August 10, 2008
261-4779-LTR-07 R/I

Subject: Resolution of NRC Questions Regarding ALION VUEZ 30 Day Testing Program
Status of Responses

Alion Problem Statement No. 5

Figure 1: Velocity Streamlines in VUEZ Tank

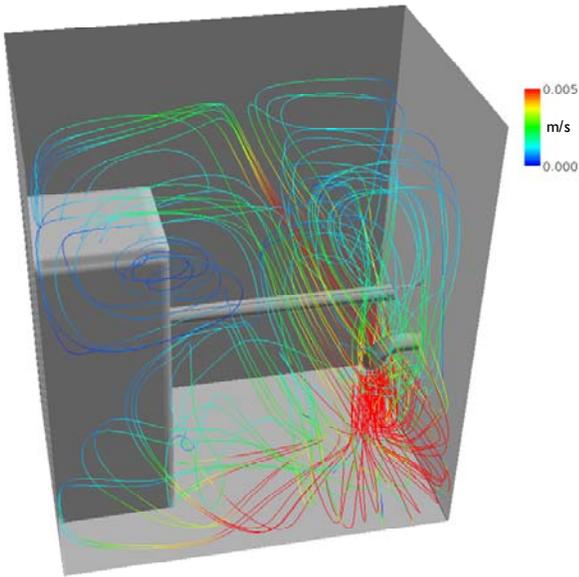
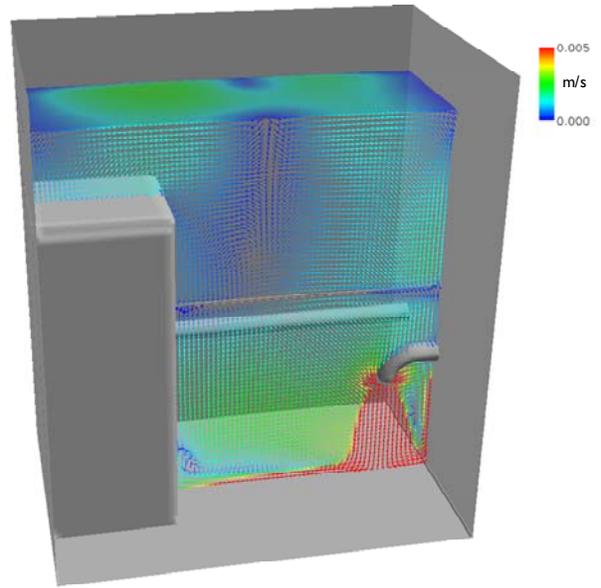
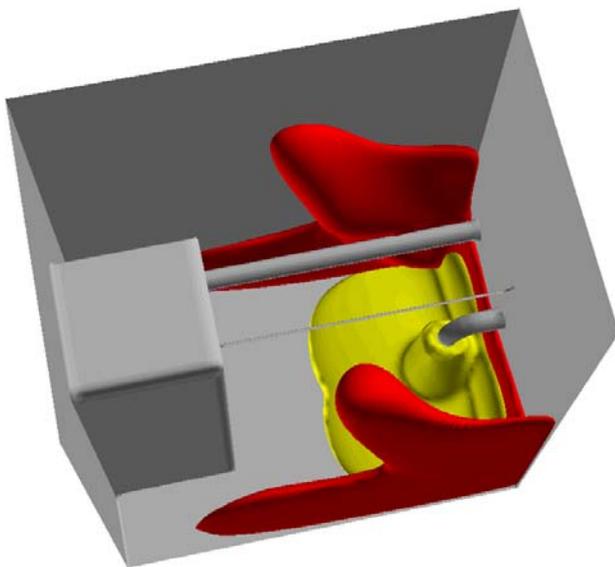
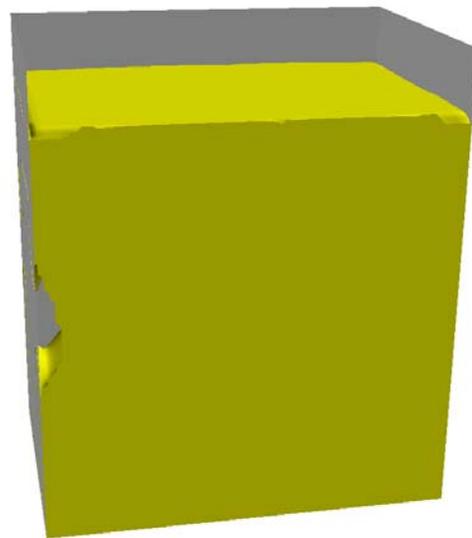
- 10. Alion should (a) procedurally document the extent of debris settlement in the tank for each test and the justification for any observed settling being acceptable and (b) demonstrate that reduced flow rates and the addition of sample baskets and coupons does not cause non-prototypical settling in the test tank.**

The VUEZ tests are a combination of leaching tests and head loss tests designed to capture the chemical interactions and their impact on debris head loss. The procedure for debris bed formation as observed by the NRC is a pouring process that ensures all of the debris is located on the debris screen. There exists the potential for particulate to arrive prior to the full fiber source is on the screen and pass through the screen and remain in circulation in the tank. The turbulence levels (TKE) in the tanks are high enough to ensure that all 10-micron particulate remains in suspension and thus arrive at the screen after a period of pool turnovers. Based on this bed formation process and tank turbulence, there is no concern relative to debris settlement in the tank that belongs on the screen.

There also exists debris and materials that represent submerged materials in containment. These materials and debris sources are “settled” debris and do not belong on the screen. For these debris sources, the pool turbulence should be such that this debris is not “transported” to the sump screen. If the turbulence levels were to transport a portion of this debris to screen, it would be have a negligible effect and be conservative.

The last concern would be the potential for any chemical precipitate to settle in the tank area and not be transported to the sump screen and impact head loss. These chemical precipitates are considerably more transportable than 10-mircon particulate (silicon carbide) which has been shown to remain in suspension by CFD.

Alion has performed a CFD of the VUEZ test tank in with a flow rate of 0.7 liter/minute which supports the above statements regarding turbulence and velocity fields. The following figures illustrate the CFD results.

Figure 7: Silicon Concentration with Solid Bottom (Case 1)

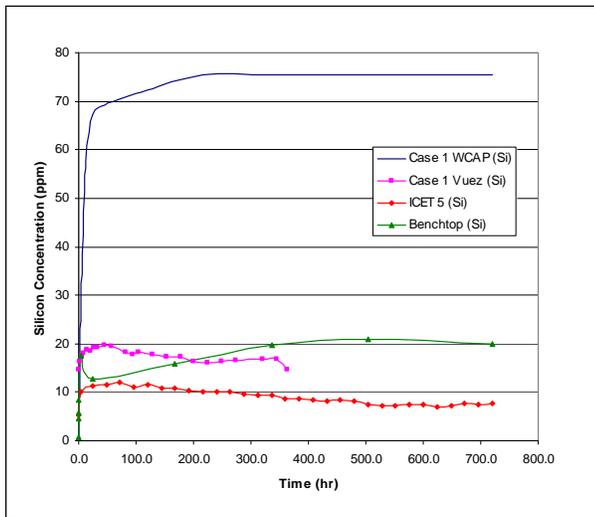
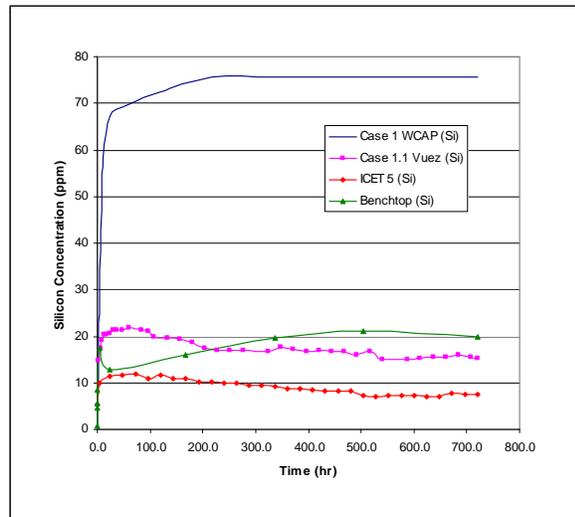
- 20. Alion should demonstrate that, for coupons and debris baskets that are only in the test tank for a discrete period of time, the potential for slow or non-uniform mixing of the test fluid and the potential for unevenly mixed chemical constituents does not have a non-conservative impact on the corrosion/degradation of the coupons and debris baskets, which are assumed to be in contact with well-mixed test fluid for the entire period of immersion.**
- 21. In light of the staff observations of debris densely packed into baskets, debris baskets with only one open side, and debris baskets and samples being tightly spaced in the test tank, Alion should demonstrate that the test tank fluid at VUEZ can interact with the materials in the tank in a representative manner.**

The baskets were all of the same size for each of the experiments although debris quantities changed for each of the plants based on their specific debris conditions. SEQ#4 Cases 2, for example, contained a considerable amount of submerged fiberglass debris (see Figure 6). In this case, there is a concern relating to the interaction of the fluid and interior of the submerged fibrous debris. The NRC pointed out this concern when witnessing a plant specific VUEZ test and test technicians suggested a full screen tray (top and bottom) could be utilized to promote a more through mixing. Alion and VUEZ concurred that this could enhance mixing and made the change solely on a good practice judgment and not any analytical investigation.

SEQ#4 Case 1.1 was a restart of Case 1 due to a pump seal failure in Loop 1 midway through the experiment. Case 1.1 utilized the new basket type and can therefore provide a comparison on the silicon concentrations between the two basket designs (Case 1 is approximately 50% of the Case 2 fiber load). The silicon concentrations between the two loops are provided in Figures 7 and 8. As shown from the fluid ICP analysis between the two (2) loops, the difference is negligible. This is most likely due to the considerable amount surface area of the bulk fiberglass in the tray. The concentration is less than that predicted by the WCAP but is consistent with the benchtop work performed in an integrated environment and comparable to the ICET silicon levels. Table 2 provides a comparison of the quantity of fiber to the pool volume for the various experiments.

Figure-2: 2800 ppm B (boric acid) with 0.7 ppm Li (LiOH) (1) and with 180 ppm Al and TSP to pH 8.5 (2)
(Solution remains clear)

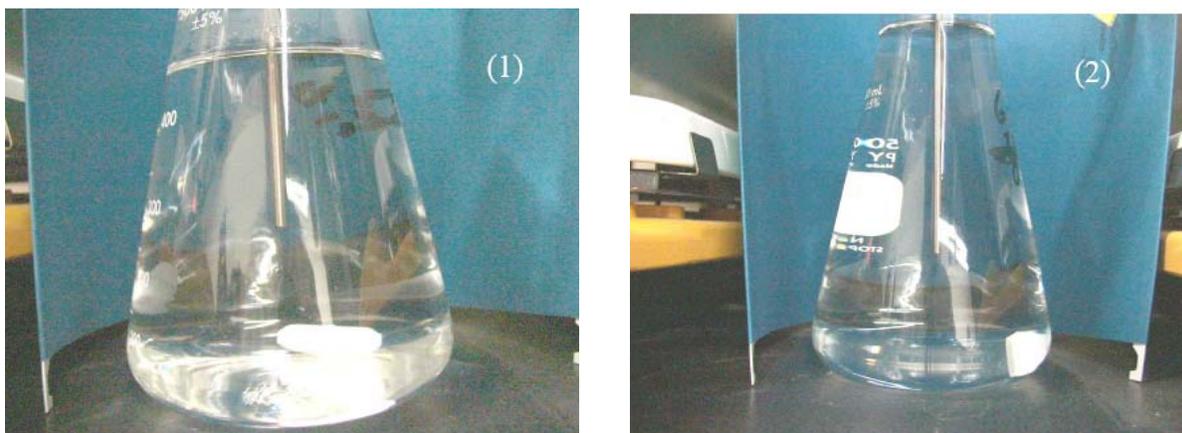
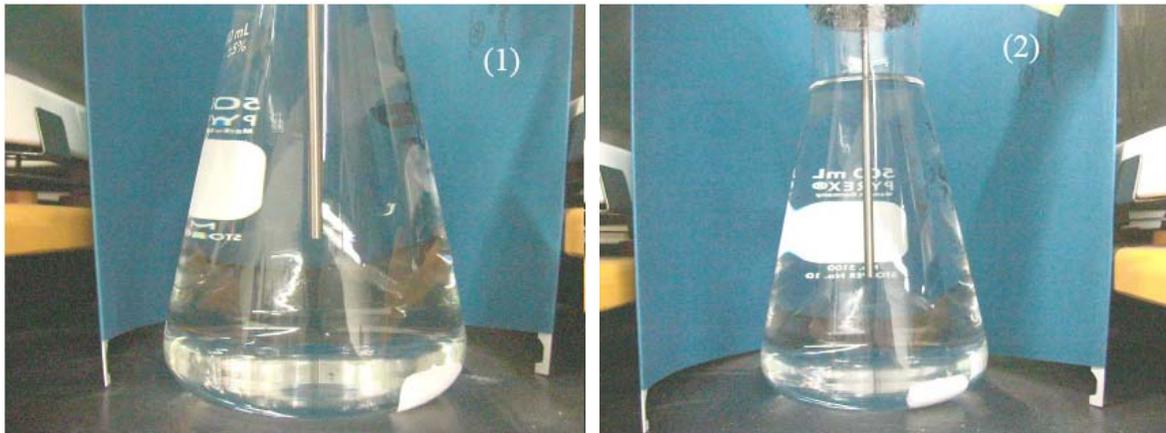
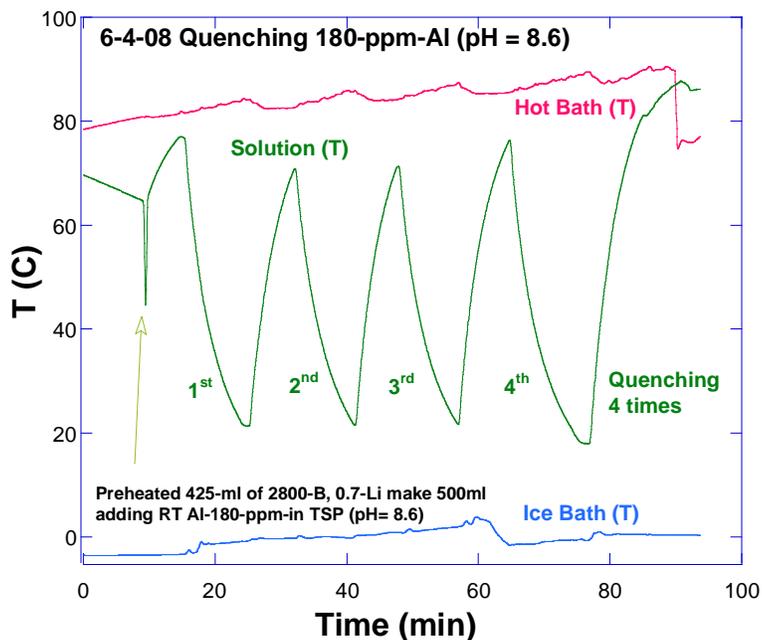
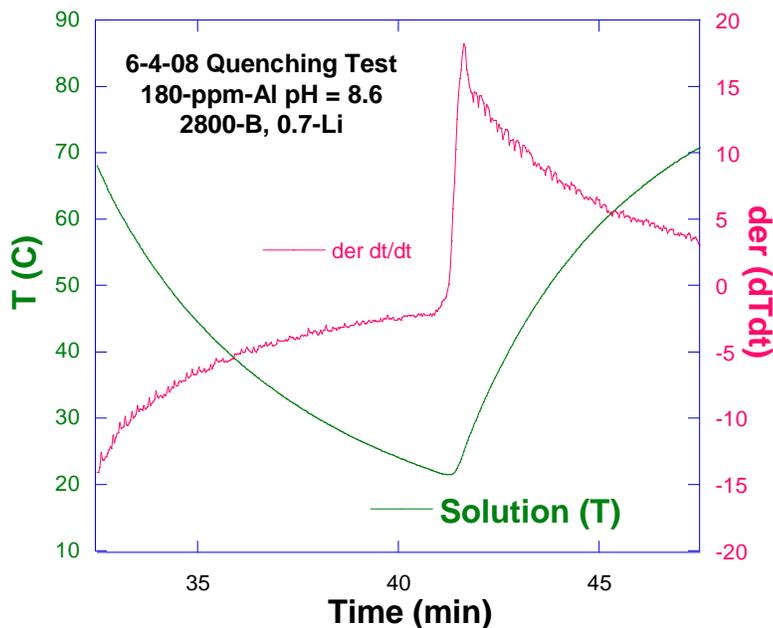
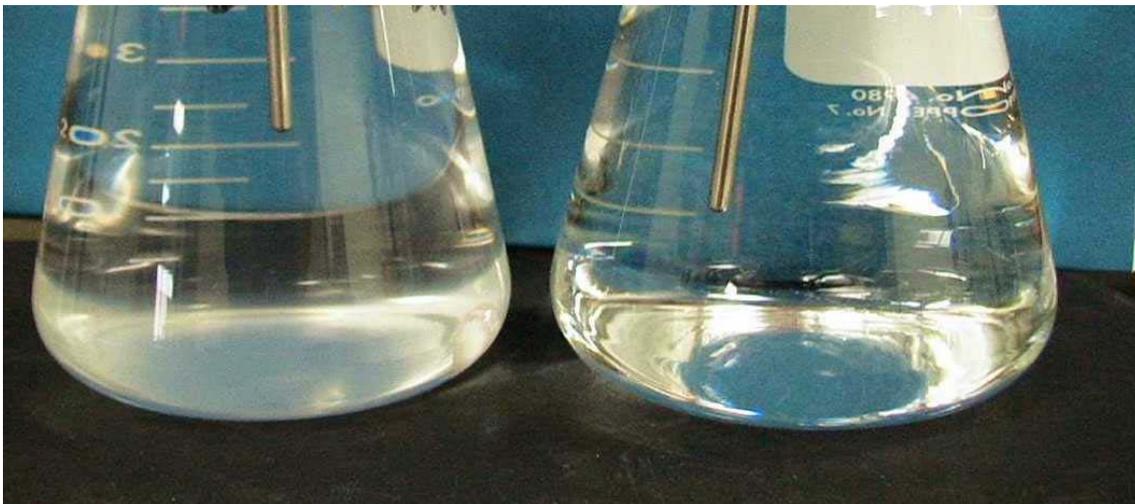
- 16. Alion should (a) describe the impact of thermal cycling of the test fluid to represent a sudden temperature drop in a heat exchanger and (b) demonstrate that neglecting this effect does not have a significant adverse impact on the VUEZ test results.**

The second test was performed with the solution initially at 158° F, followed by ice-water quenching to room temperature (70° F), and heated back up to the 158° F. The solution was heated and quenched four (4) times in ten minute intervals. The ice-water quenching did not accelerate the process for the development of emulsion nor does the precipitate instantly form during the cooling process. The exposure of the solution to the decreased temperature in the RHR heat exchanger would be for a relatively short period of time and as illustrated in this experiment would not result in precipitation in the heat exchanger or affect the process of precipitation.

The four quenching tests indicated that no cloudiness was observed from the 180 ppm Al solution during the test period shown in Figures 2 through 4. The solution remained very clear. As shown in Figure 5, the T and derivative (dT/dt) vs. time for the quenching test, there was no physical changes observed. The estimated solubility of Al is as shown in Figure 6 for the T and pH ($20 (68^\circ\text{F}) < T (F) < 70 (158^\circ\text{F})$, pH = 8.5) is 5 ppm. With $\text{Al} < X (T, \text{pH}) < 180 \text{ ppm Al}$, the Al concentration exceeded the estimated solubility, but no cloudiness was observed. This could indicate that the precipitate does not develop under these test conditions. The previous test (test #1) showed that the cloudiness took a few days to become visible.
